RE: In the Matter Of: The Application Of Kentucky Utilities Company For A Certificate Of Public Convenience And Necessity To Construct A Selective Catalytic Reduction System And Approval Of Its 2006 Compliance Plan For Recovery By Environmental Surcharge - Case No. 2006-00206

CASE NO.
2006-00206

RESPONSE OF
KENTUCKY UTILITIES COMPANY
TO
SECOND DATA REQUEST OF
COMMISSION STAFF
DATED AUGUST 21, 2006

Chart I

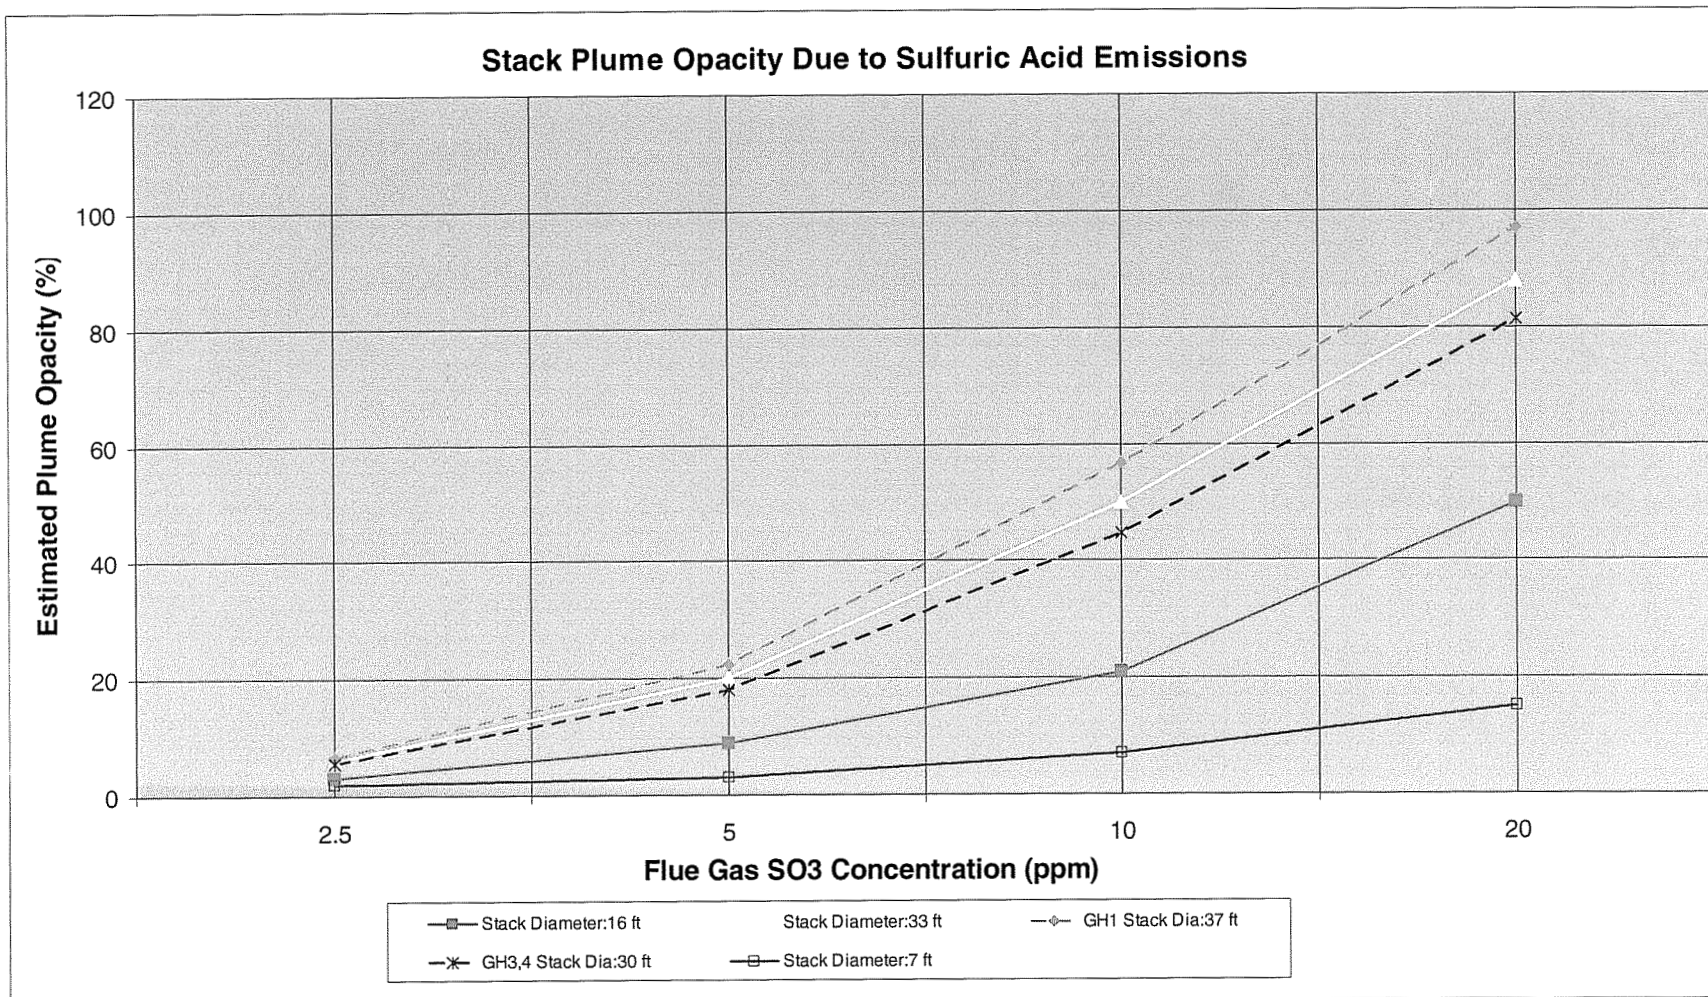
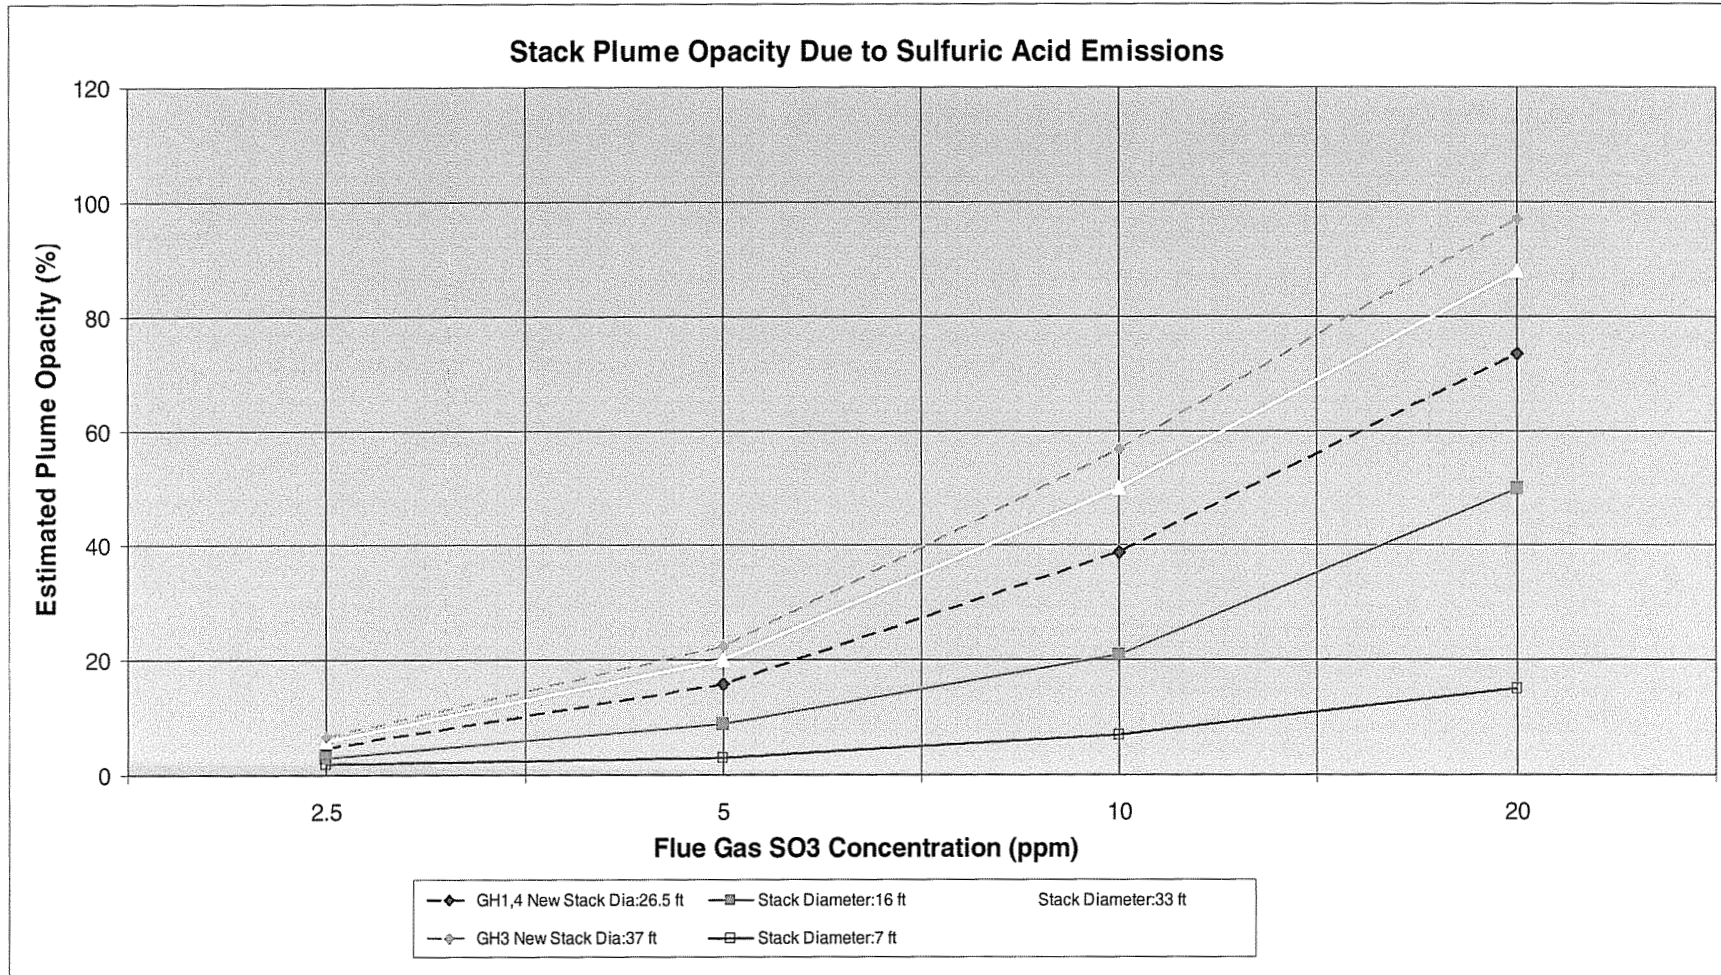
- b. Page 8 of 42 in Exhibit JPM-4 shows a chart relating flue gas SO₃ concentration with estimated plume opacity for different stack diameters. What are the diameters of the stacks at Ghent Units 1, 3, and 4?
- c. Provide copies of the Environmental Protection Agency's Method 9 protocols referenced in the response to Item 4(d).
- A-3. a. The Electric Power Research Institute ("EPRI") has issued an SO₃ mitigation guide based on their research and industry experience with SO₃ emissions and mitigation technologies. The report and a portion of the response to this question are being filed with the Commission under seal pursuant to a Petition for Confidential Protection [REDACTED]

[REDACTED] As included on Page 8 of 42 in Exhibit JPM-4, EPRI provides a chart relating flue gas SO₃ concentration with estimated plume opacity for different stack diameters (see response to item 3b below). By interpolation, the Ghent stack diameter curves can be plotted on the graph (see attached Graph 1 which shows the current stack diameters for the Ghent units). As indicated by this graph, a target of 5 ppm SO₃ concentration in the flue gas should allow the Company to maintain the plume opacity below 40% for Ghent 1, and 20% for Ghent 3 and 4 (the current regulatory limit on opacity for these units). Therefore, 5 ppm SO₃ concentration in the flue gas was selected as the screening level for SO₃ emission mitigation alternatives in order to control plume opacity and maintain compliance with current opacity regulations at Ghent Station.

Post-FGD construction, the stack diameter for all three Ghent units will change. Per the attached Graph II, the Ghent 1 plume opacity may be maintainable at a slightly higher SO₃ concentration (~8 ppm), reducing the required sorbent injection flow for this unit. Ghent 3 may require an increase in sorbent injection to maintain the plume opacity below 20%, due to the increase in stack diameter. Ghent 4 will remain substantially the same, per Graph II. However, final operational control parameters will be established through testing and calibration for each unit and application of USEPA Method 9 testing.

- b. At Ghent Unit 1, the current stack diameter is 37 feet. The FGD construction project will move Ghent Unit 1's flue gas to a stack with a diameter of 26.5 feet. The Ghent Unit 3 current stack diameter is 30 feet. The FGD construction project will combine Ghent Unit 3's flue gas with Ghent Unit 2 in a stack with a diameter of 37 feet. The Ghent Unit 4 current stack diameter is 30 feet. The FGD construction project will move Ghent Unit 4's flue gas to a stack with a diameter of 26.5 feet.
